**Water Right Conditions
Tracking Slip**

FILE ## G-17401

PUBLIC INTEREST REVIEW FOR GROUND WATER APPLICATIONS

A. GENERAL INFORMATION: Applicant's Name: Joe and Joyce McKay County: Malheur

Application G-17401, Joe and Joyce McKay

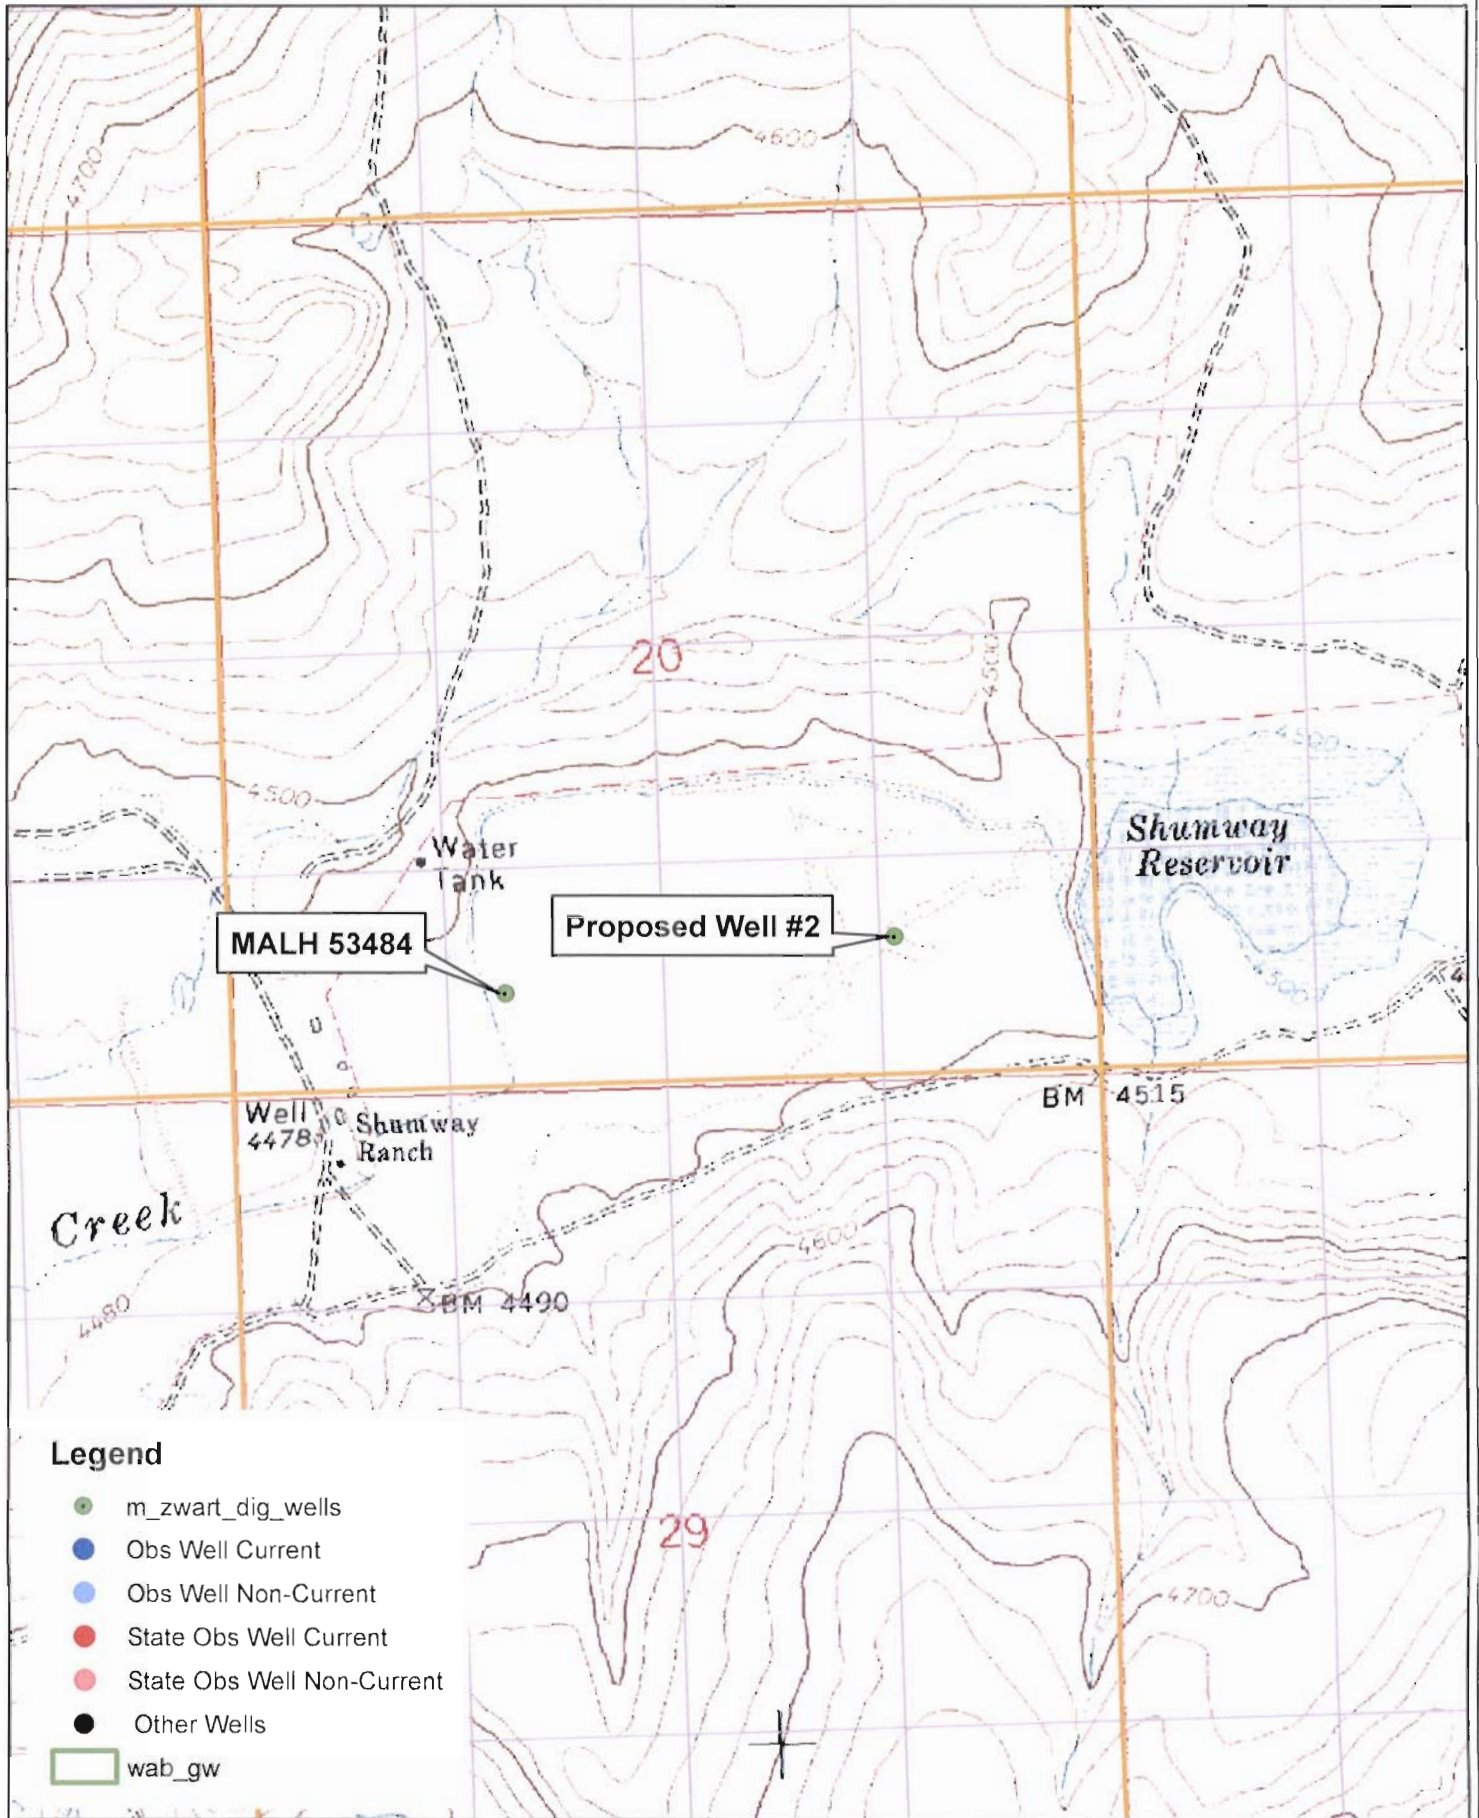
B3. **Ground water availability remarks:** There are no reasonably close observation wells. There is limited groundwater development in this area, which is remote. Only two well logs are on file in a 20-square-mile area surrounding the site.

Basis for aquifer confinement evaluation: The water level in both local wells is above the depth that groundwater was first encountered.

Basis for aquifer hydraulic connection evaluation: Both local wells have water levels well below the nearby reach of the creek. Proposed well #2 may have a considerably deeper water level than is estimated here, based on the reported water level in MALH 52092 located nearby. It does not appear that groundwater is providing baseflow to local creeks.
